### 3B Containment Hydrodynamic Loads

The information in this appendix of the reference ABWR DCD, including all subsections, tables, and figures, is incorporated by reference with the following departures.

STD DEP 3B-2 (Table 3B-1, Figures 3B-12 and 3B-13)

Figure 3B-12 Time History of Air Bubble Pressure

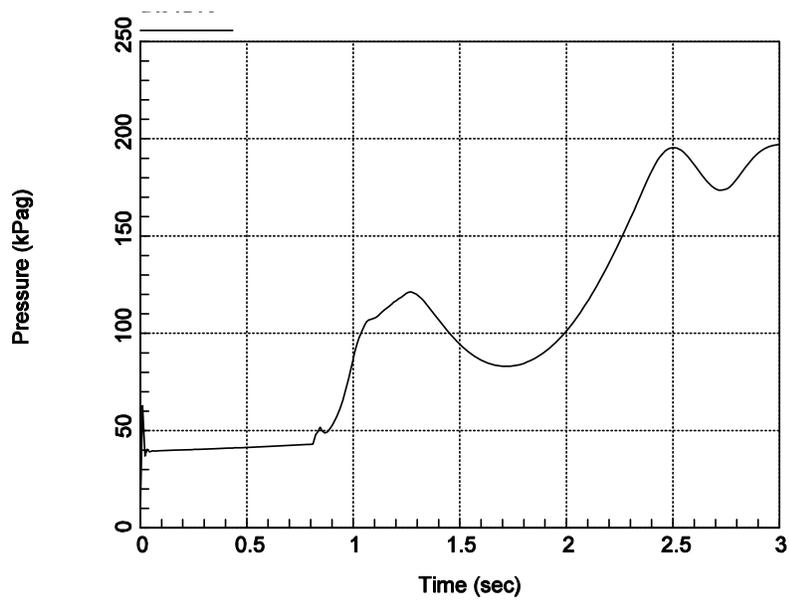
Description	Value
1. Air bubble pressure (maximum)	<del>133.37 kPaG</del> <b>195 kPaG</b>
2. Pool swell velocity (maximum)	<b>10.9 m/s</b>
3. Wetwell airspace pressur (maximum)	<del>107.87 kPaG</del> <b>146 kPaG</b>
4. Pool swell height (maximum)	<del>7m</del> <b>8.8m</b>

Figure 3B-13 Schematic of the Pool Swell Phenomenon

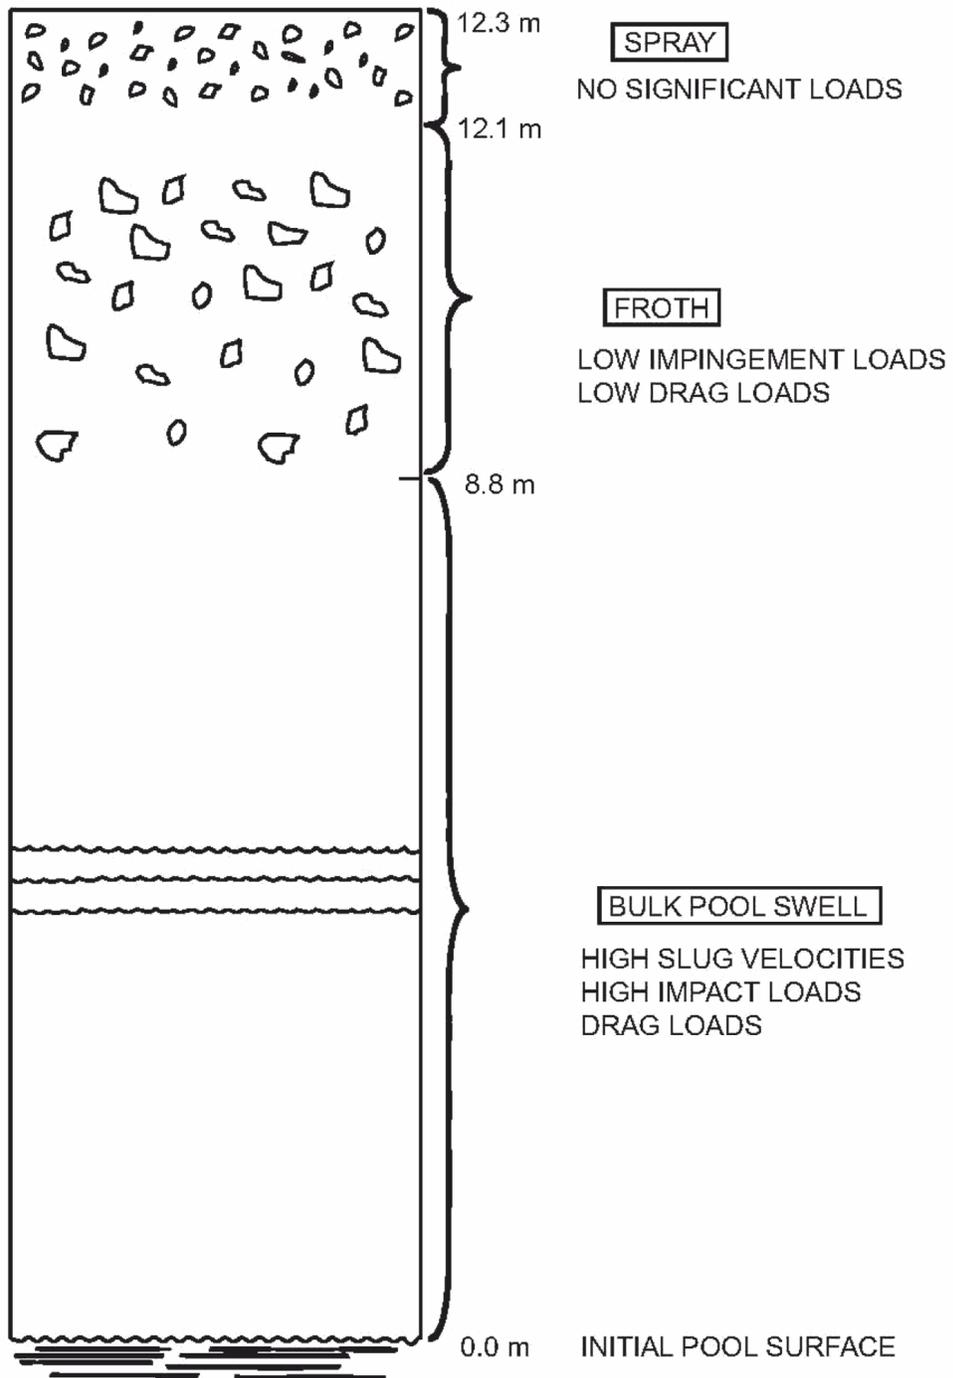
Structures located between 0 and ~~7m~~8.8m above the initial surface will be subjected to impact load by an intact water ligament, where the ~~7m~~8.8m value corresponds to the calculated maximum pool swell height. The load calculation methodology will be based on that approved for Mark II and Mark III containments (NUREG-0487 and NUREG-0978).

Structures located at elevations between the ~~7m~~8.8m and ~~40.3m~~12.1m will be subjected to froth impact loading. This is based on the assumption that bubble breakthrough (i.e., where the air bubbles penetrate the rising pool surface) occurs at ~~7m~~8.8m height, and the resulting froth swells to a height of 3.3m. ~~This froth swell height is the same as that defined for Mark III containment design and this.~~ This is considered to be conservative for the ABWR design. Because of substantially smaller wetwell gas space volume (about 1/5th of the Mark III design), the ABWR containment is expected to experience a froth swell height substantially lower than the Mark III design. The wetwell gas space is compressed by the rising liquid slug during pool swell, and the resulting increase in the wetwell gas space pressure will decelerate the liquid slug before the bubble break-through process begins. The load calculation methodology will be based on that approved for the Mark III containment (NUREG-0978).

As shown in Figure 3B-13 the gas space above the ~~40.3 m~~12.1m elevation will be exposed to spray condition ~~including~~ which is expected to induce no significant loads on structures in that region.

Figure 3B-21 ABWR CO Source Load Methodology

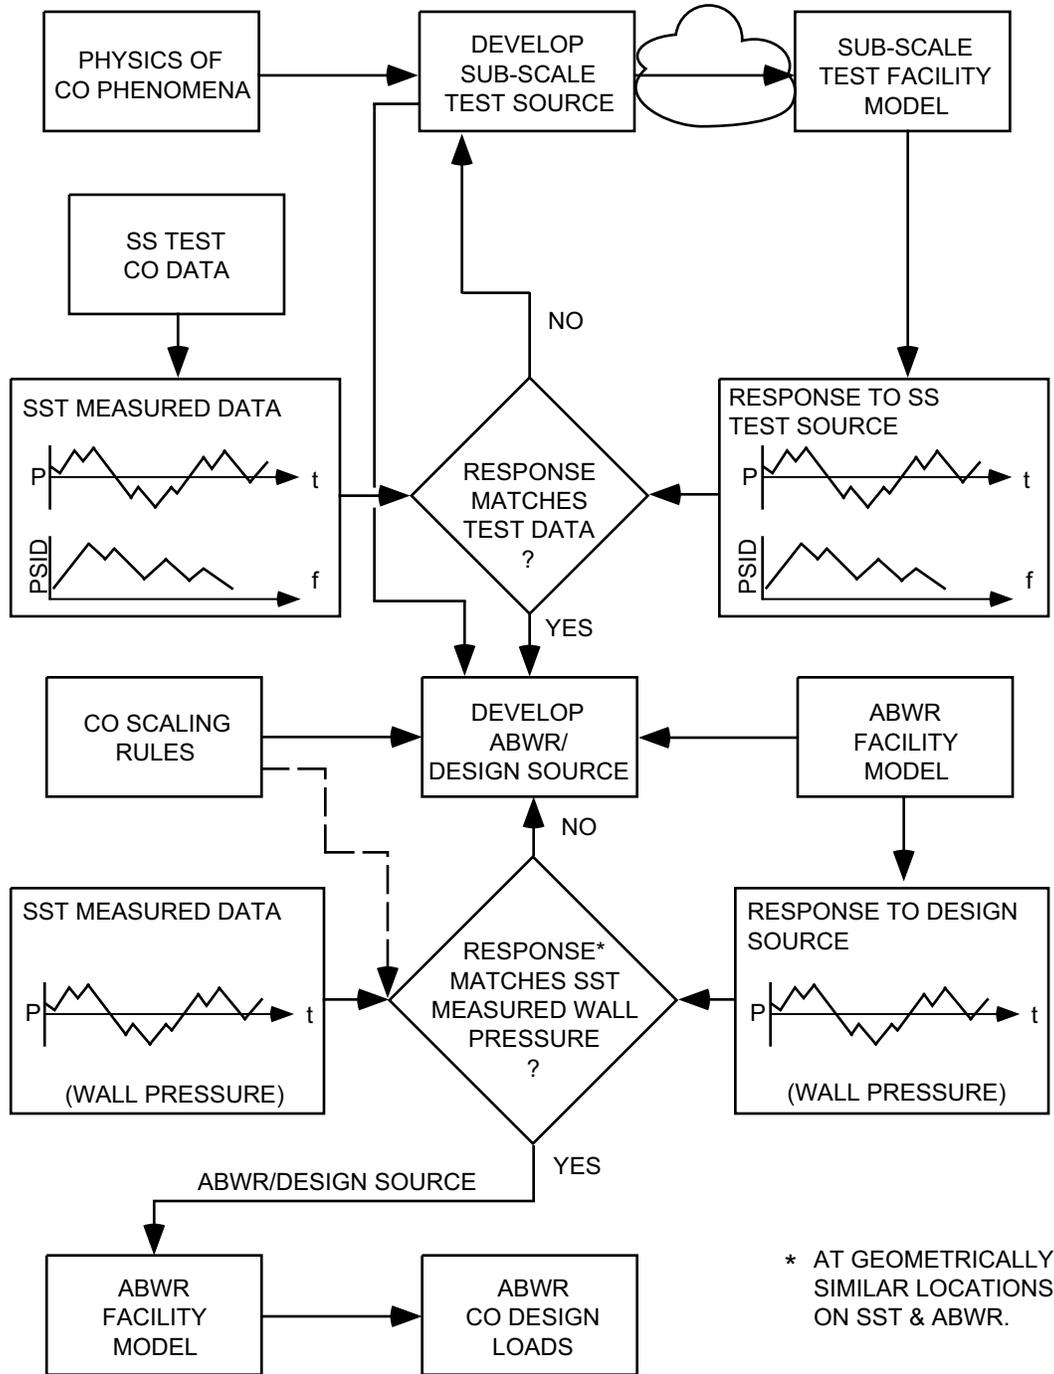
STD DEP Admin (Figures , 3B-21, 3B-24, 3B-26)
